AMERICAN ENERGY CORPORATION

RE: Response to Comments, Bennoc Area NPDES OIL00159 Application for American Energy Corporation in Belmont County, Ohio

Response to OEPA Comments from Bruce Goff and Eric Nygaard Dated 8/21/12, 8/15/12, 7/20/12, 7/13/12, and 7/11/12 Bennoc NPDES Permit Application OIL00159

Hydro-Chemical Analysis of Waste Water Discharge and Anti-Degradation Assessment: American Energy Corporation's Bennoc Coarse Coal Refuse Area Ponds 001 and 002

Wheel treatment system – pictures provided by www.chemstream.com

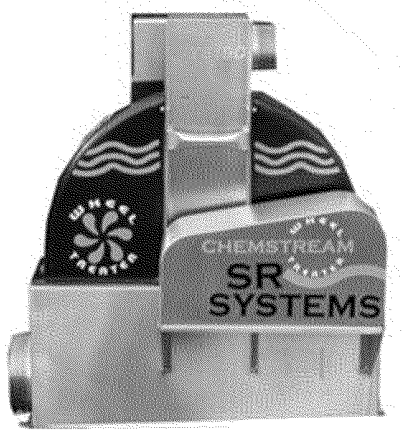
Comment: Do you happen to have any photos of the treatment ponds, the outlet structures, the chemical feed equipment and the discharge drainage ways (outlet ditches) you can share?

Response: We do not have any pictures of the proposed treatment ponds and their structures. However, we do have a picture (below) of the proposed wheel treatment system.

Section A'-A

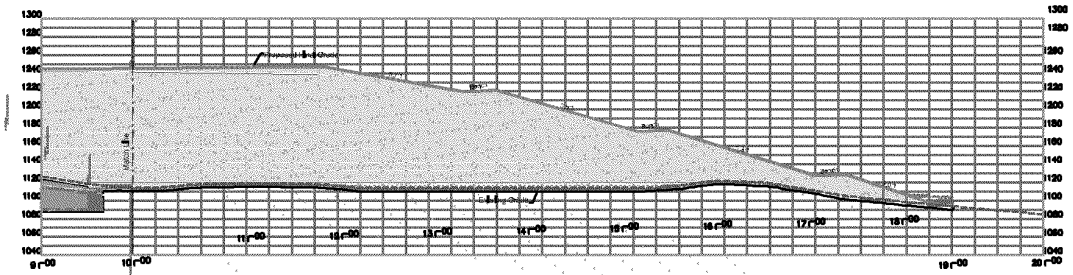
Comment: Also send us some typical cross sections of the refuse disposal area. Include a cross section before disposal of refuse, a cross section during disposal and a final cross section showing final grades and reclamation.

Response: Cross sections of the area for before disposal and after reclamation can be found in the attached drawing Sections A'-A & B'. During disposal cross-sections would be difficult to supply due to the constant change during construction.
